## Response to Submissions

SSD 18\_9347

Sydney Metro Martin Place - Integrated Station Development  
Stage 1 Amending Development Application (SSD 18\_9347)

Submitted to Department of Planning and Environment  
On behalf of Macquarie Corporate Holdings Pty Ltd

**Figure 1 Approved elevation plan showing tower built to the southern boundary**

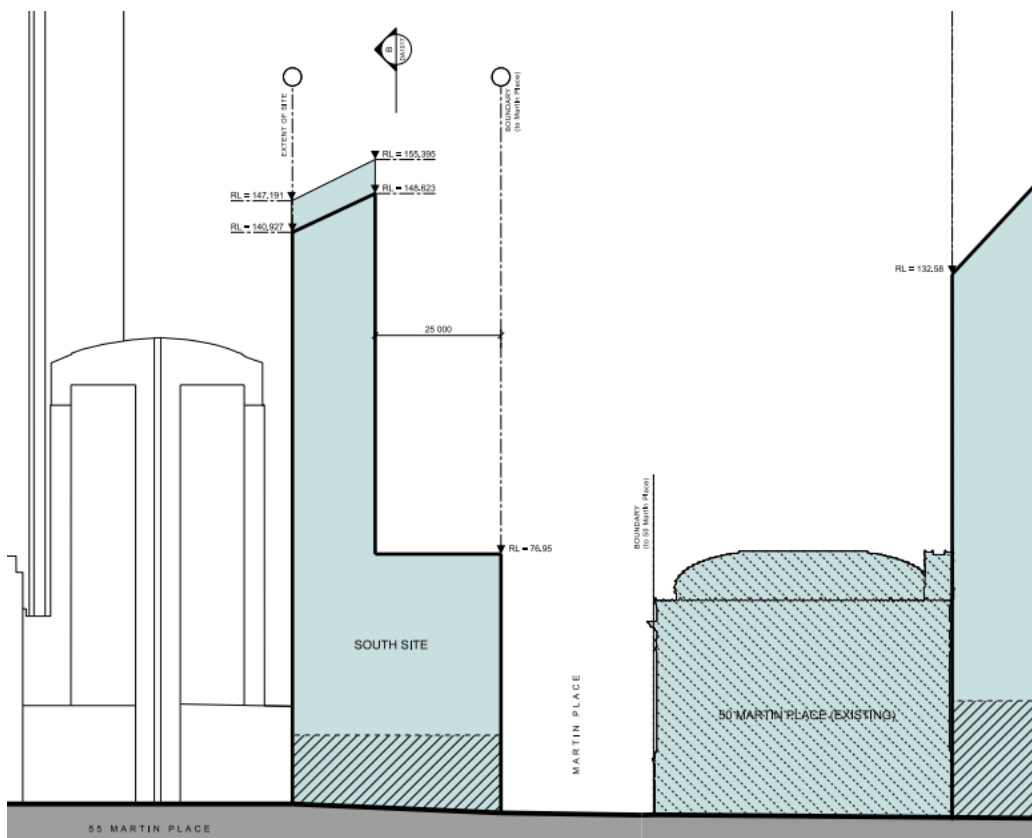
The submission from the City of Sydney recommends the inclusion of 8m by 8m recesses (cut-outs) at the southern corners of the South Tower building envelope above the podium. It was suggested that these recesses would provide 'a transition to the adjoining development to the south above the podium height' and reinforce 'the importance of the urban character and integrity of Martin Place and the associated city blocks'.

**The Concept Proposal (SSD 17\_8351) and consolidated Design Guidelines have already approved the principle of a tower built to the southern boundary along its full extent, as shown in Figure 1 and Figure 2 below.**

**Figure 5 Illustration of the building envelope including the City's suggested amendments having regard to the establishment of a threshold condition to Martin Place and the Metro Precinct**

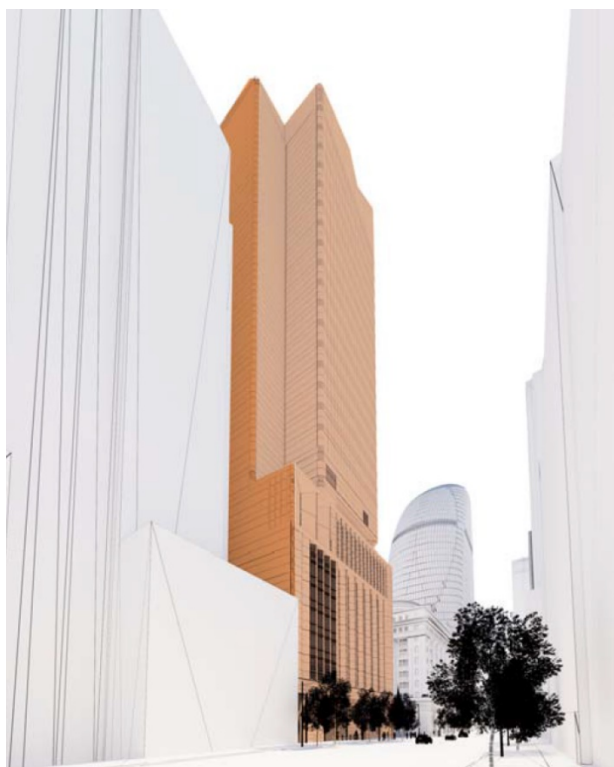
Introducing recesses at the southern corners of the tower will be detrimental to the creation of a defined threshold to Martin Place and the Metro Precinct; a key principle approved in the Concept Proposal's Consolidated Design Guidelines.

Including corner recesses at the tower level will undermine this threshold condition and thereby undermine the ability of the development to provide a clear sense of arrival to Martin Place. This will have the effect of diminishing Martin Place's differential or 'specialness' when moving through the city and as a one of Sydney's most important civic spaces.

**Figure 4** illustrates the role of the southern wall in creating a threshold to Martin Place, with **Figure 5** modelling the suggested recesses and demonstrating its detrimental effect on the implementation of this principle by weakening the definition of this threshold edge.

**Figure 6 Comparison of proposed envelope and City's suggested amendments having regard to the establishment of a unique podium height to Martin Place**

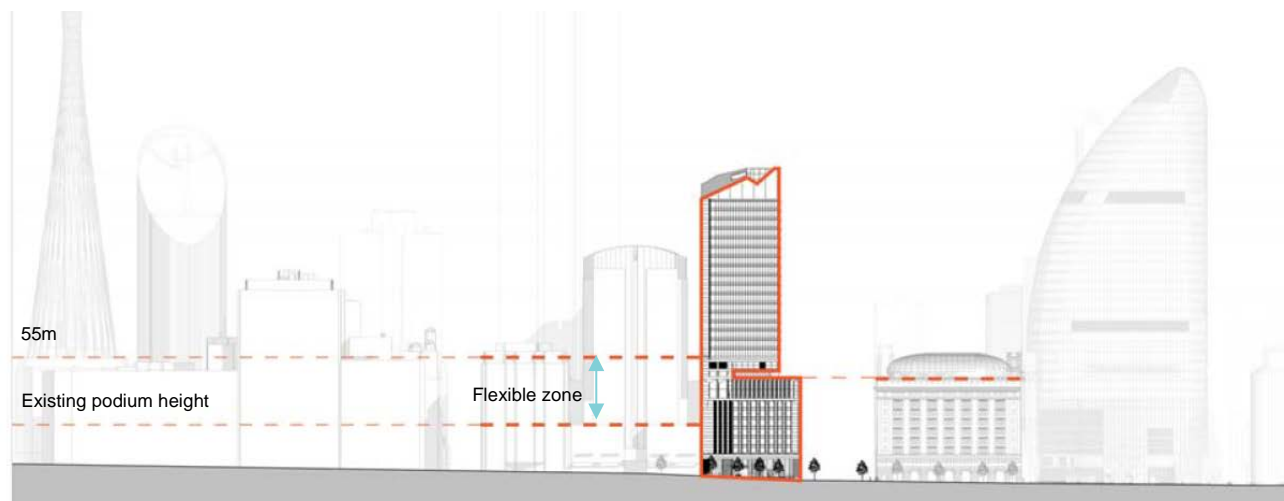
The proposed zero setback scheme also provides flexibility for the height of podium buildings to the south of the South Site, whilst establishing a distinct character for Martin Place. In fact, a change of podium height in future developments to the south, when compared to the defined relationship between the South Tower and 50 Martin Place, enhances the importance and distinctiveness of Martin Place in the context of the streetscapes of both Elizabeth Street and Castlereagh Street.

**Figure 6** compares the two approaches and demonstrates how the proposal ensures a unique podium height to Martin Place.

*Proposed scenario: Ensures the uniqueness of the Martin Place podium height*

*Suggested corner recesses scenario: Dictates a podium height for sites to the south commensurate with the Metro Precinct*

**Figure 7 Elizabeth Street elevation illustrating the impact of 8x8m recesses as proposed by the City of Sydney**

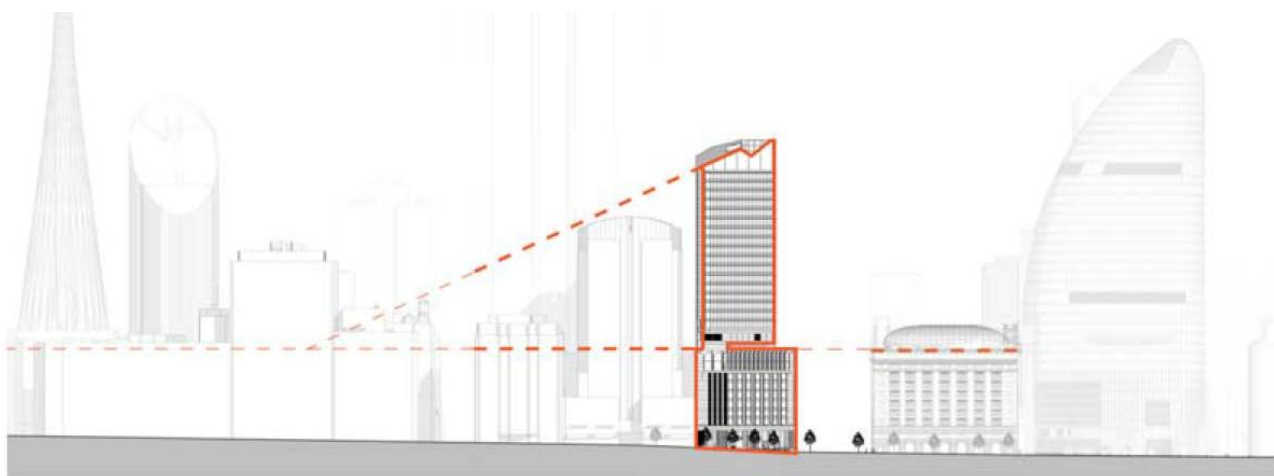
Neither the approved Concept Proposal envelope, nor the proposed amendment, dictate or infer a podium height and/or street frontage setback for buildings to the south of the site. This situation allows greater flexibility and redevelopment options for these sites to the south, especially when considering they are already significantly constrained in terms of redevelopment potential given the Hyde Park Sun Access Plane.

The redevelopment potential of sites south of the South Tower would be substantially limited if they were required to conform to the podium and street frontage height datum suggested by Council as well as the Hyde Park SAP and would result in short, squat building envelopes; an arguably undesirable urban design and planning outcome for Elizabeth Street as an edge condition to Hyde Park. Defining the podium height could also have a potentially limiting effect on the flexibility of sites to the south to respond to the proportional relationship between the podium and the tower (as the height of the tower above the podium would be significantly reduced). This impact is shown in **Figure 7** below.

**Figure 8 Indicative reduction in NLA for the tower and resultant floor plate**

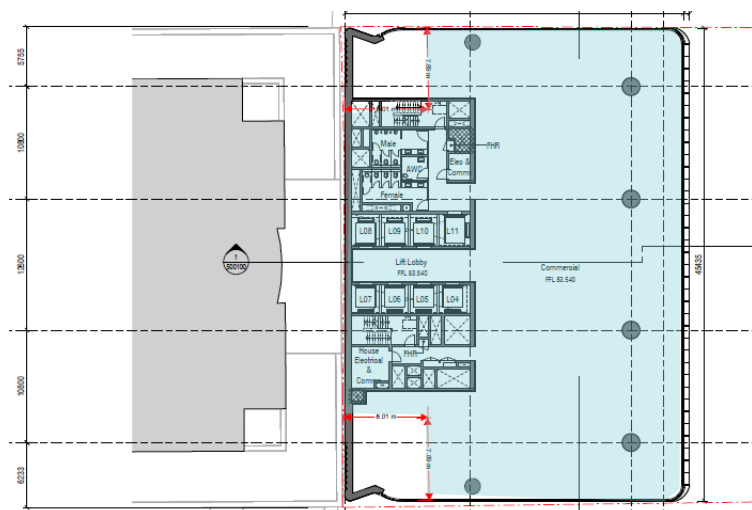
Commercial premises and floor plates that meet market needs and expectations are an essential part of building a competitive Global City. The floor plates desired by major tenants fall in a range between 1,500-2,000m<sup>2</sup> Net Lettable Area (NLA). This is reiterated by the PCA's Premium Grade applying to a commercial building, with a floor plate of 1,200 m<sup>2</sup> NLA or above. The South Tower building envelope under the Stage 1 Amending DA offers 1,200m<sup>2</sup> of NLA for the podium levels and approximately 1,100m<sup>2</sup> of NLA for the tower levels above.

The introduction of 8m x 8m recesses above the podium will reduce the area of usable floor space to below 1,000m<sup>2</sup> of NLA (approximately 972m<sup>2</sup>). This reduced floorplate impacts the ability of the South Tower to attract and accommodate premium multi-floor tenants and premium global businesses, which impacts the significance of Martin Place as a commercial centre in the CBD.

A reduction in the commercial floor plate will also fail to meet the unique strategic potential of the site or attract premium tenants. The proposed development is located above two intersecting rail lines/stations with immediate access to both the Metro and heavy rail networks. The site is uniquely and ideally placed to link high-quality commercial space with a major investment in public transport infrastructure.

**Figure 9 Current Sydney Metro TSE Martin Place South Site program**

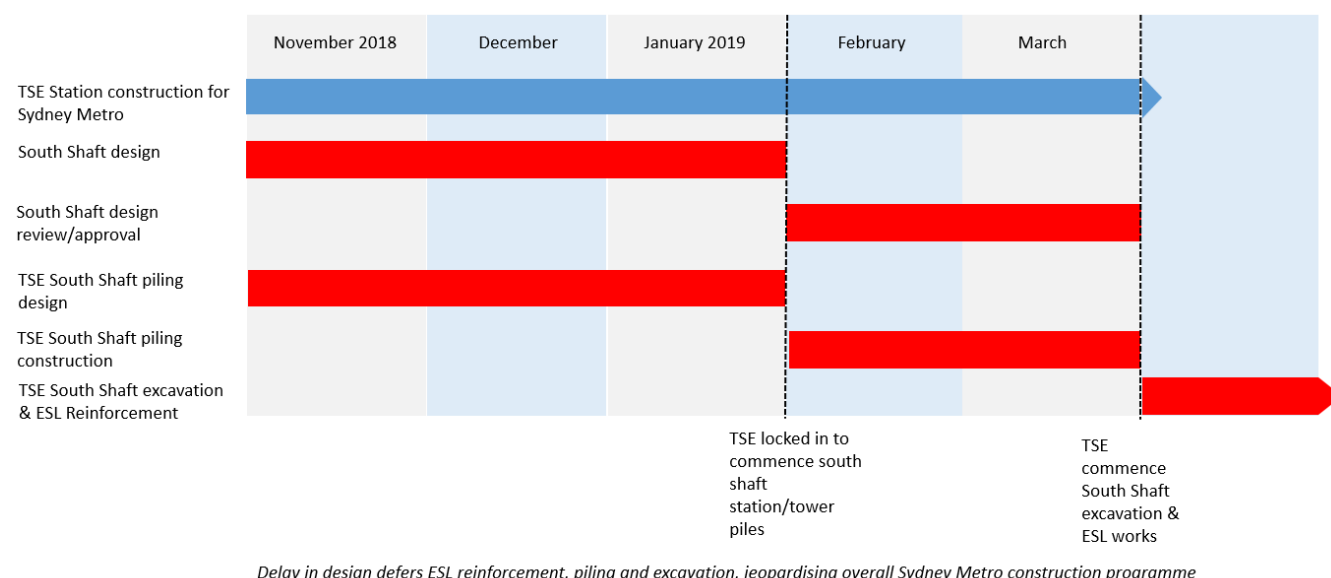
With this information at hand, the impact to the detailed design of the project that will ensue from the introduction of building envelope recesses as suggested by the City, (in terms of structure and integration of the OSD and station components), would necessitate a redesign of the OSD.

Likewise with the design of the station, given the constraints of the Eastern Suburbs Line (ESL) Rail tunnels and the Metro Tunnel and Station Excavation (TSE) works, a re-evaluation of the southern section of the station would be required to accommodate the City's suggested envelope changes, given the highly integrated vertical nature of the design from the OSD down to the station.

These changes will not be achievable within the timeframe to deliver the integrated project. Any changes that put in jeopardy the design and delivery of the Sydney Metro project, which these suggested recesses would potentially do, are not considered to be reasonable, especially when considering there is proven (as detailed above) to be little to no benefit if implemented.

**Figure 9** illustrates the current process and timeframe agreed between Sydney Metro and the TSE contractor for the design and construction of the Martin Place Station (South) and ESL interface (noting that the TSE station construction, south shaft piling design and south shaft excavation design are currently in progress).
